Metro Outer Development Assessment Panel Agenda

1. Declarations of Due Consideration
2. Disclosure of Interests
3. Form 1 DAP Applications
 - 3.1 Lot 95 (323) Great Eastern Highway, Midvale – Service Station – DAP/23/02563
4. Form 2 DAP Applications
5. Section 31 SAT Reconsiderations

NEW SERVICE STATION COMPLEX
323-325 GREAT EASTERN HIGHWAY MIDVALE WA

SIGNAGE ELEVATIONS 1:100 AT A1

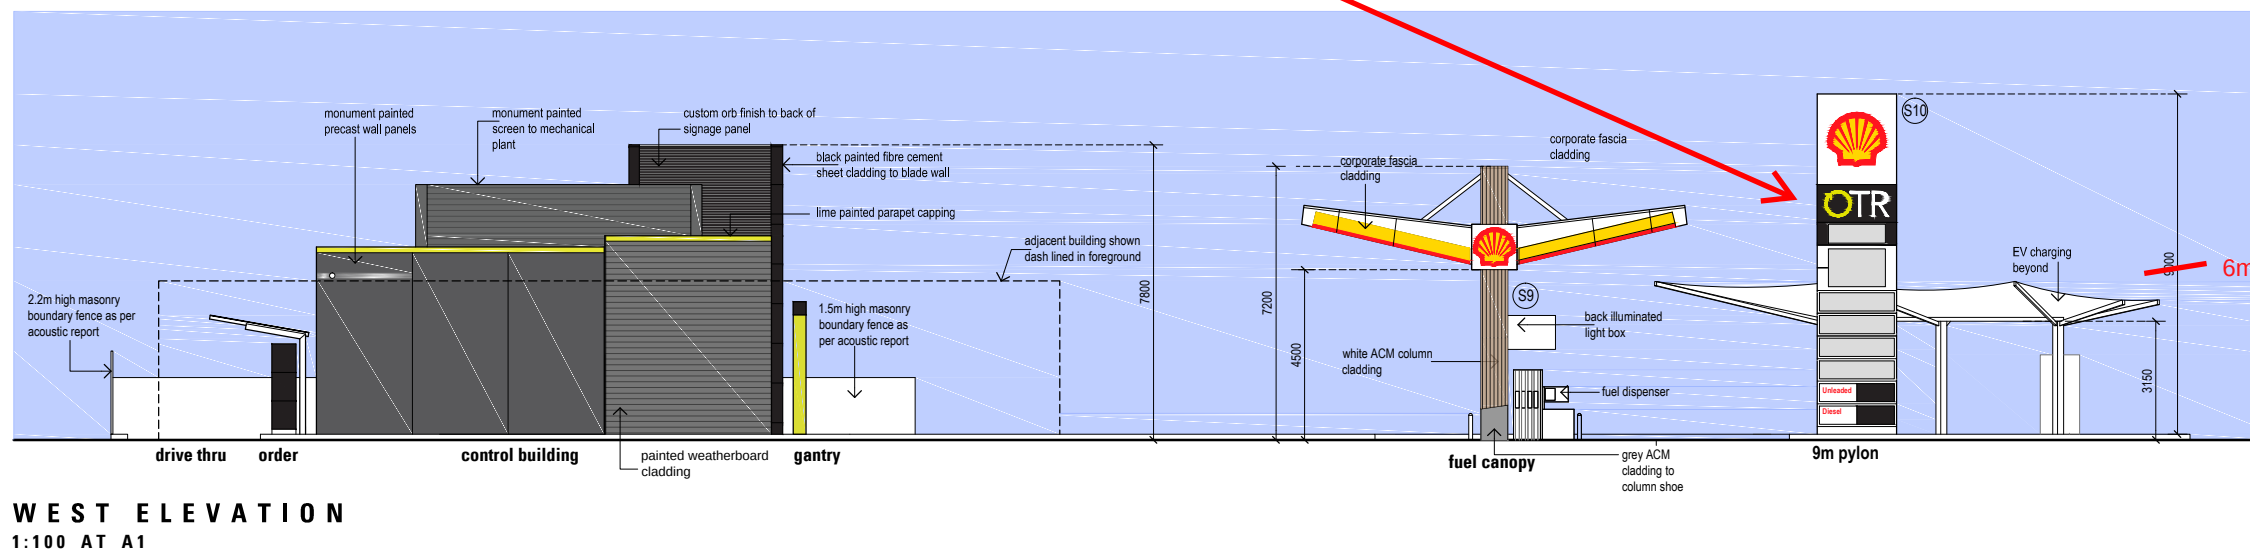
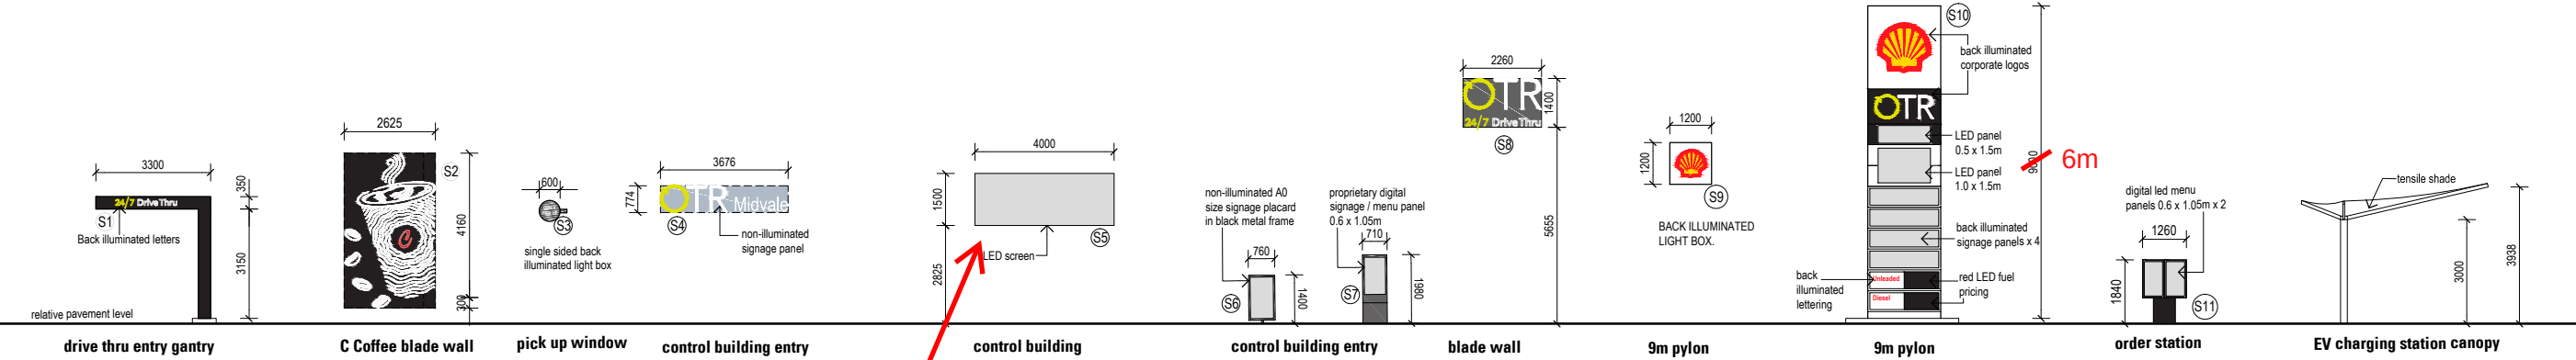
Pylon sign to be reduced to 6m (refer condition 15)

Pylon sign to be reduced to 6m (refer condition 15)

14. Floodlights shall be located and angled to minimise light spill onto adjoining land.
15. The proposed pylon sign shall not exceed 6m in height.
16. Buildings and structures that are indicated on the site plan to be removed shall be demolished and materials removed to the satisfaction of the Shire.
